For Construction Permit for a New TV Station on Channel *39

in Bakersfield, California

SECOND MOTION TO ENLARGE ISSUES

ENGINEERING EXHIBIT IN SUPPORT OF OPPOSITION TO A PETITION FOR LEAVE TO AMEND

EXHIBIT 3-A FROM VPT APPLICATION DATED MAY 6, 1993

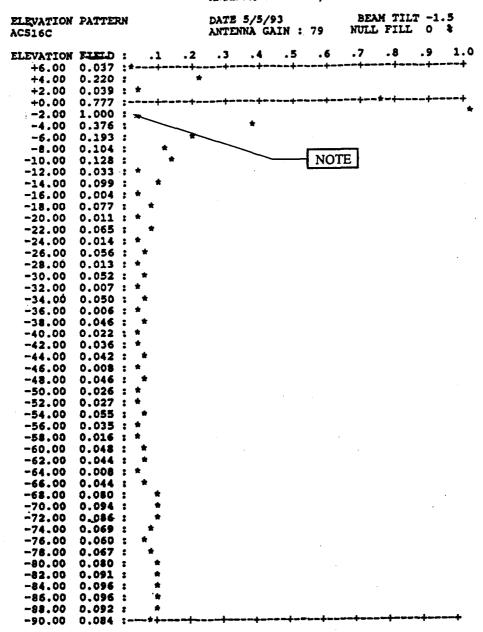
- 3. VPT's response to Section V-C, ¶10, indicates that it will employ a 1.5' electrical beam tilt, but, as explained in the engineering exhibit prepared by Hammett & Edison attached hereto as Exhibit 1, the antenna pattern shown in Exhibit 3-A to the Amendment is for an antenna with a 2.0' beam tilt. This discrepancy makes it impossible to determine the contours of the proposed facility and thus the areas and populations which VPT proposes to serve. Accordingly, an issue should be specified requiring VPT to clarify its engineering proposal and correct this inaccuracy so that a valid assessment can be made of the areas and populations it will serve.

From Figure 5, it can be seen that if the tabulation in Exhibit 3-A of the VPT application is taken as correct, then the maximum effective radiated power towards the radio horizon is only 251 kW. If, on the other hand, the 1.5° of electrical tilt shown in Item 10(d) of Section V-C of the VPT Form 340 is taken as correct, and if the 1.000 relative field at -2.00° tabulation in Exhibit 3-A is ignored, then Figure 6 shows that the maximum effective radiated power towards the radio horizon is 370 kW as claimed by VPT. The differences in effective radiated power that the half-degree ambiguity causes are shown in a polar format by the attached Figure 7.

Of course, if the elevation pattern relative field maximum of 1.000 at -2.00° given in Exhibit 3-A is taken as correct, then the projected contours, area, and population within the now proposed VPT Grade B contour are all incorrect as well. It should be noted that the depression angle of the elevation pattern maximum in the Exhibit 3-A tabulation is given to three significant figures (i.e., -2.00), so this angle cannot be construed as 1.5° rounded to the nearest integer.

Antenna Concepts Inc. Model ACS16C Elevation Pattern 2.0° Electrical Tilt

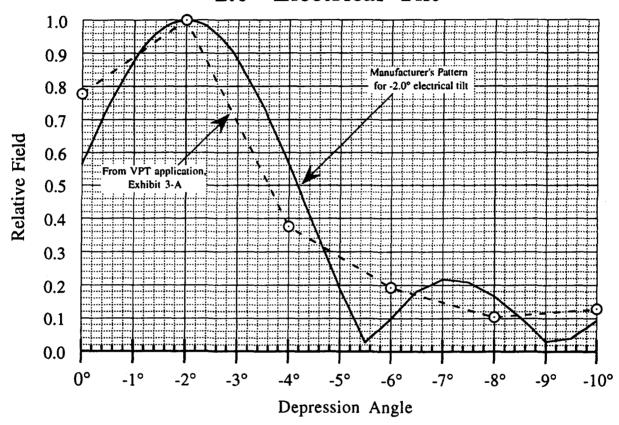
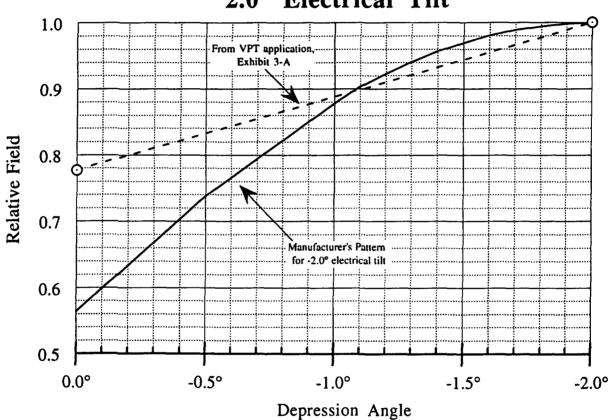
For the effective height of the VPT antenna now proposed at Mt. Adelaide, the radio horizon occurs between 0.15° and 0.80° below horizontal. Thus, the critical portion of the elevation pattern occurs between 0° and 2° below horizontal. From the expanded elevation pattern shown in Figures 3B and 4B, corresponding to the proposed antenna with either 2.0° or 1.5° of electrical beam tilt, the spread sheets in Figures 5 and 6 have been derived.
